# PRODUCT / PROCESS CHANGE NOTIFICATION

## PCN-000863

Date: OCT-20-2022

Hisense, a CM for Semtech, has upgraded its print marking from ink to 2D laser marking. This change will be applied to the affected numbers on ROSA products that use metal barrels.

1. Laser marking machine

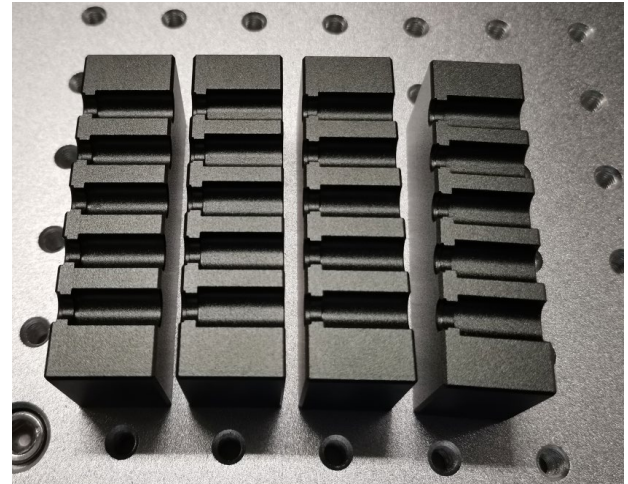
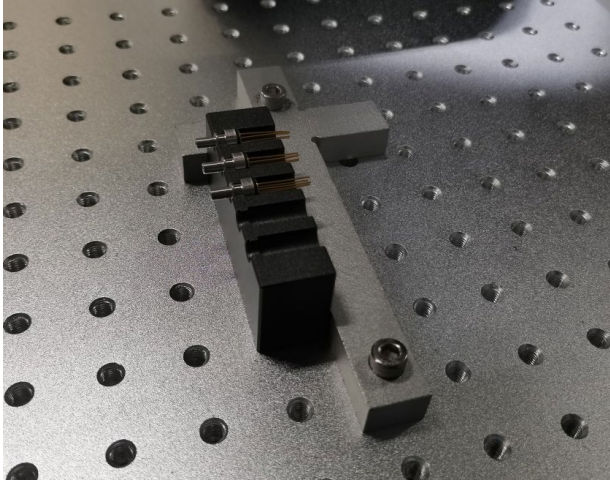
- **2D Laser Marking**
